### Office of Superintending Engineer World Bank Project Circle P.W.D., Kanpur

Letter No.:- 801 / 5C-WBPCK / 2023

Construction of 2-lane missing link road from Rath Bypass (Hamirpur District) to Garautha (Jhansi District) of SH-42 in the State of Uttar Pradesh— (Online Forest Proposal No.-FP/UP/ROAD/117342/2020) Regarding Regional Empowered Committee's (REC), IRO(MoEF&CC), Lucknow EDS Compliance Status Report.

We refer to the above REC Minutes of Meeting (MoM) and the discussions we had on subject matter. Kindly find a point wise reply of user agency on the essential details sought by the Regional Empowered Committee's REC, IRO(MOEFCC) Lucknow as below:

### Digital Georeferenced GIS Map of Proposed CA Land in the Range of Kuchecha, District Hamirpur Under Proposed UPCRNDP-SH42 Missing Link 79°25'4"E

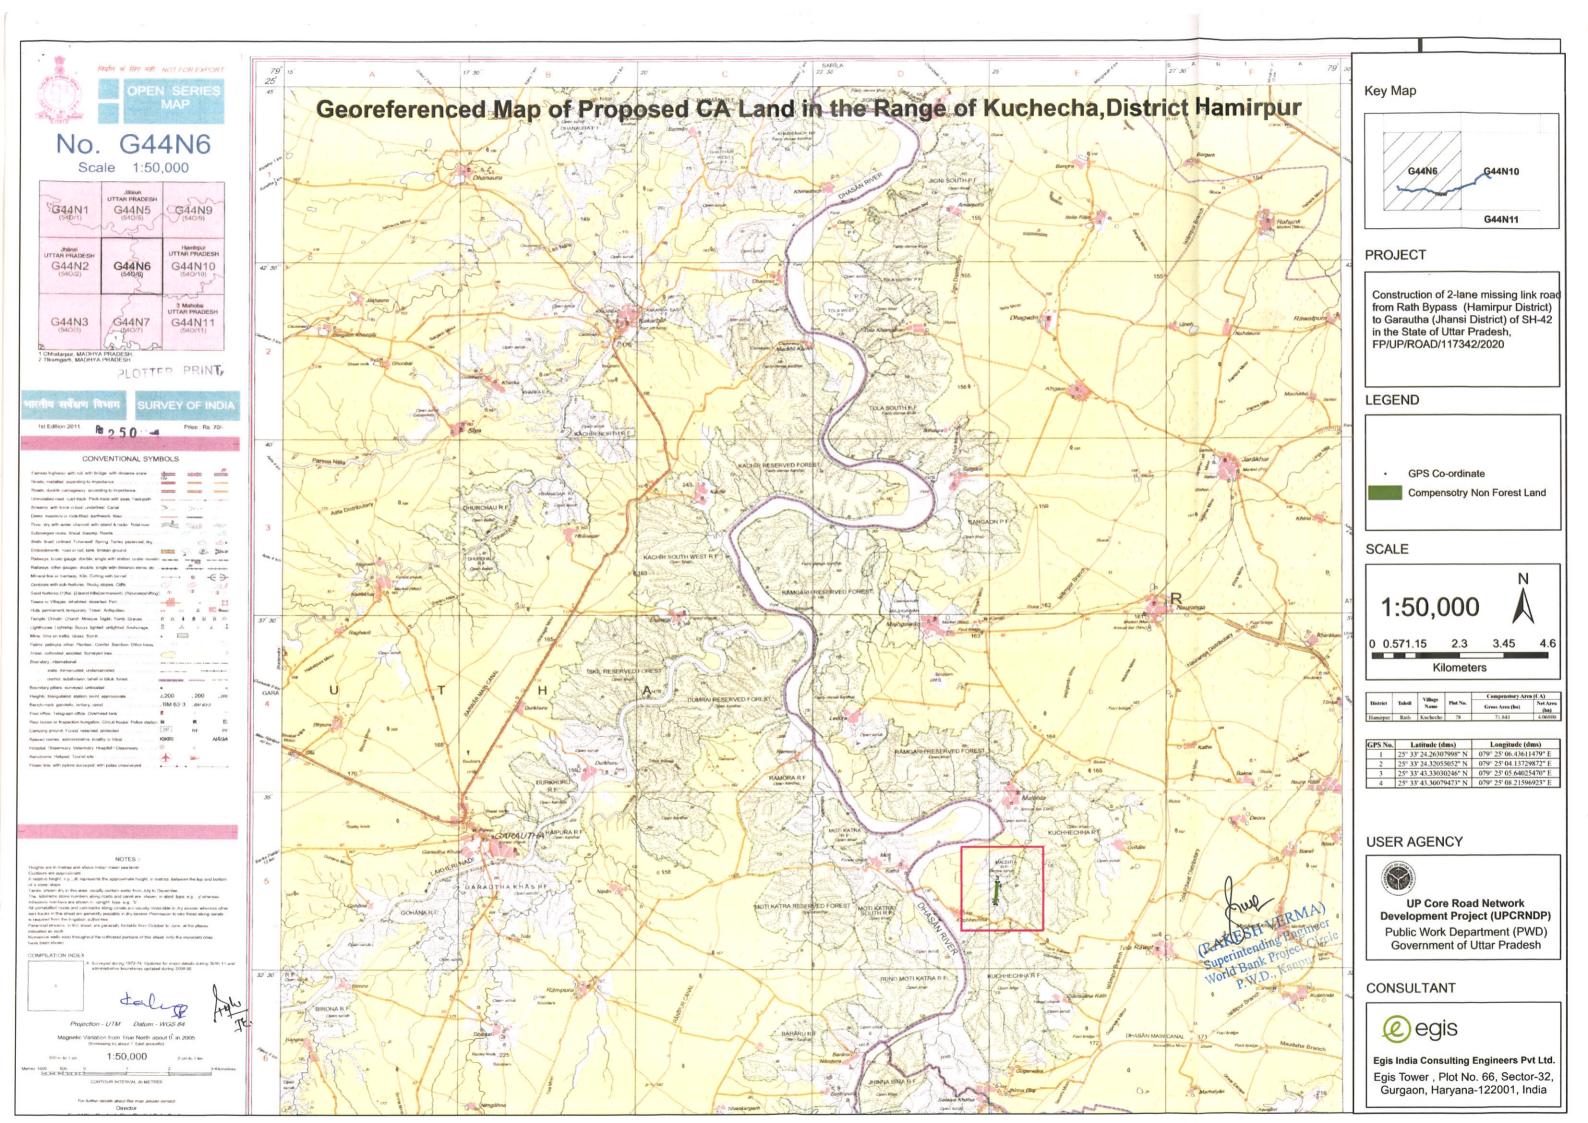
2.	As per the DSS and SOI toposheet, the proposed NFL CA land polygon falls under the Kuchhechha R.F and Durkhuru R.F area. This needs rectification/ clarification.	A new fresh Non-Forest land for CA Purpose has been allocated by DM, Hamirpur vide its letter No. 856/ DLRC-12A-Punargrahan (2022-23) dated 01.05.2023. The copy of same along with the Georeferenced map, SOI and KML for the same land is enclosed as Annexure-2.1.

# TCS-1A - NEW CONSTRUCTION + BYPASS IN RURAL SECTION

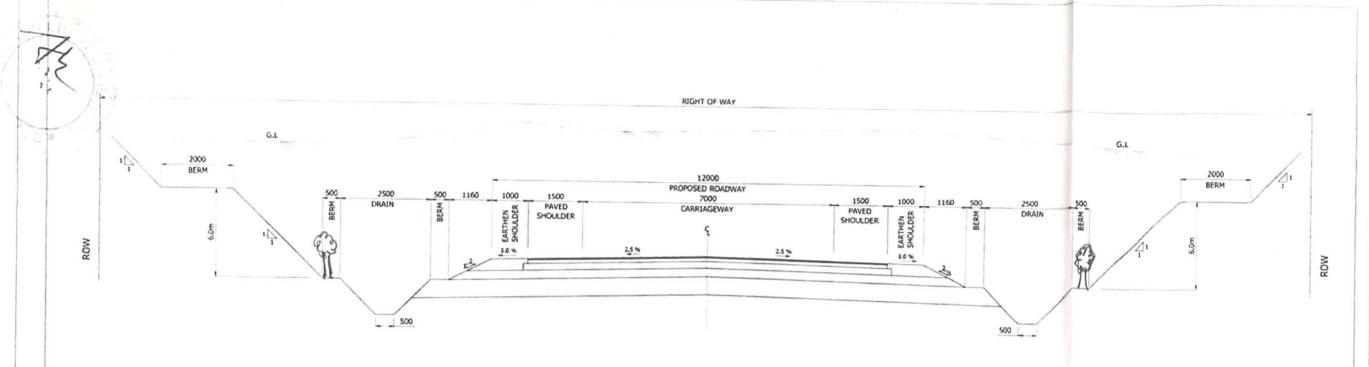
7.	Details of existing ROW, Proposed ROW and	The widening varies throughout the alignment
	land width (ROW) availability for road side	proposed under project. The list of the Existing
	plantation needs to be submitted and	ROW, Proposed ROW is enclosed herewith as
	accordingly plantation scheme for roadside	Annexure-3 for reference. The Tree Plantation shall
	plantation needs to be submitted.	be carried out based on the availability of space
		within ROW. A detailed roadside plantation scheme
		on Typical Cross Sections is enclosed herewith as
		Annexure-5.
